**RE: 3020 Rio Grande Blvd. NW**  
**Grading and Drainage Plan**  
**Engineer's Stamp Date: 01/30/23**  
**Hydrology File: G13D030A**

Based upon the information provided in your submittal received 07/26/2022, the Grading & Drainage Plan is **not** approved for Building Permit and Grading Permit. The following comments need to be addressed for approval of the above referenced project:

ENGINEER'S SEAL	LOT 8-B ALVARADO GARDENS ADD 3020 RIO GRANDE BOULEVARD  GRADING AND DRAINAGE PLAN	DRAWN BY DEM
		DATE 1-28-23
1/30/23	 P.O. BOX 33924 ALBUQUERQUE, NM 87199 (505) 321-9099	SHEET # C1
DAVID SOULE P.E. #14522		JOB #

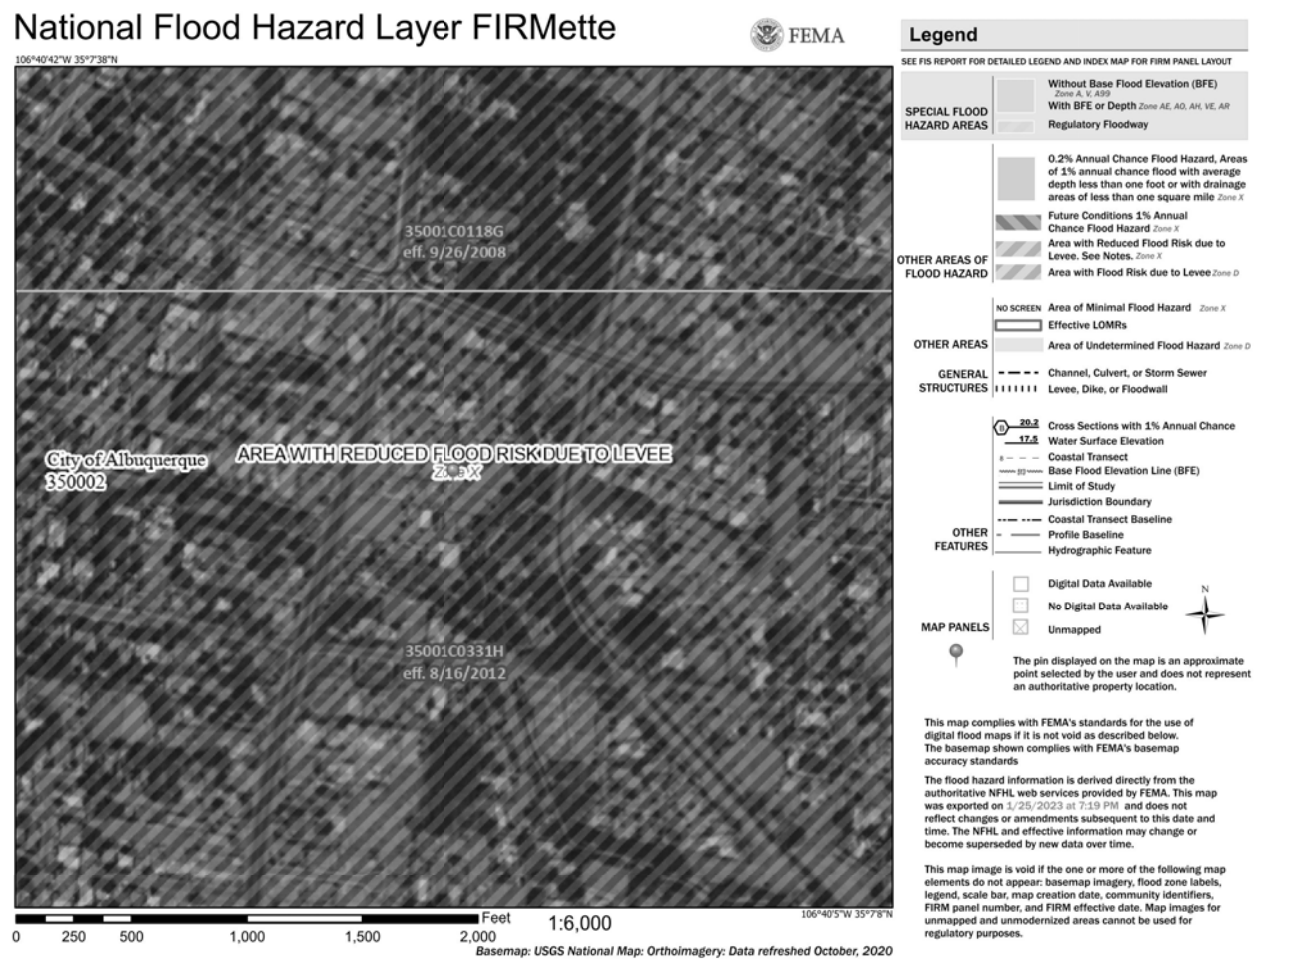
1. Please provide survey information and grading all the way to Rio Grande Blvd.

2. Please label Rio Grande Blvd. on the drawing.
3. In the drainage writeup, it states that this site is a redevelopment of a previously developed lot. This is false. The lot was subdivided for a development that never happened. Also, it states, that the ponds will overflow to the street in the event of a storm exceeding the 100-year event, this is also not true. Rio Grande Blvd is a few feet higher than the site at the Right-of-Way and this site drains to the east towards this lot. More than likely this site will actually drain to the Campbell Ditch when it exceeds the 100-year event.

4. Since this site is in the Valley region, please follow Article 6-5 Valley Drainage Criteria of the DPM. The following conditions must be applied to the site:

- a. The maximum percent impervious of the lot and the contributing area may not be greater than 45%.
  - b. Pad elevation shall be a minimum of one (1) foot above the 100 year 10-day stormwater surface elevation.

- c. The flow between the front yard and back yard cannot be obstructed. The stormwater must be allowed to equalize to the same level between the front yard and back yard.

- d. A permanent perimeter wall or barrier around the development is required to contain the 100 year 24 hour storm developed runoff.
